Tesla, Inc. Service Bulletin	Replace Wiper Motor Assembly		V	
SB-24-17-006 July 2, 2024					
Classification		Section/Group	Mobile Service	Configuration	
Recall Bulletin		17 - Electrical	Can Perform (where permitted)	All	
Model	Model Year	Country/Region	Build Location	Build Location	
Cybertruck	2024	United States	Giga Texas

Figure 1 – Batch Number

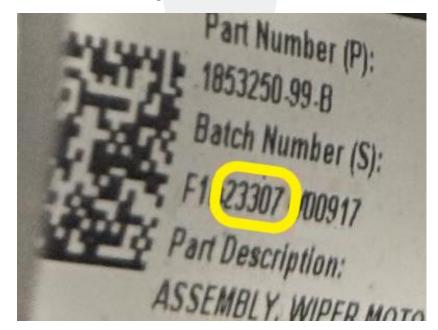
- 1. Order a new wiper motor assembly and inspect the Batch Number on the new wiper motor.
 - If digits 4–8 of the Batch Number (Figures 1 and 2) is "24145" or greater, continue to the next step.
 - If digits 4–8 of the Batch Number is "24144" or less, reject and send this wiper motor to the Material Review Board (MRB). Order a new wiper motor with Batch Number 24145 or greater, and then proceed with installation.
